United States Patent and Trademark Office

APPLICATION NO.	FILING DATE	FIRST NAMED INVENTOR	ATTORNEY DOCKET NO.	CONFIRMATION NO.	
10/003,404	12/06/2001	Koji Nii	027260-505	5384	
75	590 11/05/2002				
Platon N. Mandros BURNS, DOANE, SWECKER & MATHIS, L.L.P. P.O. Box 1404 Alexandria, VA 22313-1404			EXAMINER		
			TRAN, TAN N		
			ART UNIT	PAPER NUMBER	
		2826			
			DATE MAIL ED: 11/05/2002

DETAILED ACTION

FIG. 20

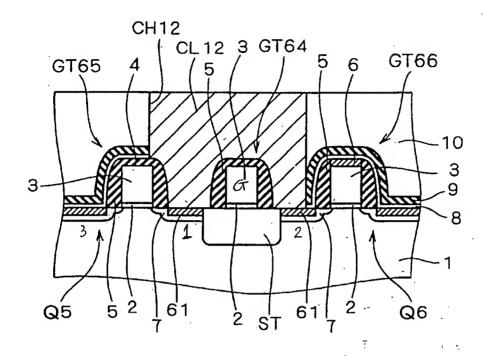
With regard to claims 1,17 Igarashi et al. disclose a gate electrode 3 formed on a substrate 1 through a gate insulating film 2 lying therebetween; first and second diffused layers formed opposite to each other across the portion of the substrate 1 existing under the gate electrode 3 and having a first conduction type, each having a second conduction type different from the first conduction type of the portion; a contact CL12 formed within a contact hole CH12 on the substrate 1. (Note attachment # 1 of Fig. 20 of Igarashi et al.).

With regard to claim 2, Igarashi et al. discloses the contact CL12 is connected also to the second diffused layer. (Note attachment #1 of Fig. 20 of Igarashi et al.).

With regard to claim 3, Igarashi et al. discloses a third diffused layer formed on the substrate 1; and an isolation area ST formed between the first and the third diffused layers, which separates the first and the third diffused layers each other; wherein the contact CL12 is connected further to the third diffused layer. (Note attachment # 2 of Fig. 20 of Igarashi et al.).

With regard to claim 4, Igarashi et al. disclose a gate electrode 3 formed on a substrate 1 through a gate insulating film 2 lying therebetween; a diffused layer formed on the substrate having first and second diffused portions formed opposite to each other across the portion of the substrate 1 existing under the gate electrode 3 and having a first conduction type, each having a second conduction type different from the first conduction type of the portion of the substrate and a third portion that connects the first portion to the second portion; a contact CL12 formed within a contact hole CH12 on the substrate 1, (Note attachment # 2 of Fig. 20 of Igarashi et al.).

With regard to claim 6, Igarashi et al. discloses another diffused layer formed on the substrate 1; and an isolation area ST formed between the first portion of the diffused layer and the another diffused layer, which separates the first portion of the diffused layer and the another diffused layer, wherein the contact is connected further to the another diffused layer. (Note attachment # 2 of Fig. 20 of Igarashi et al.).
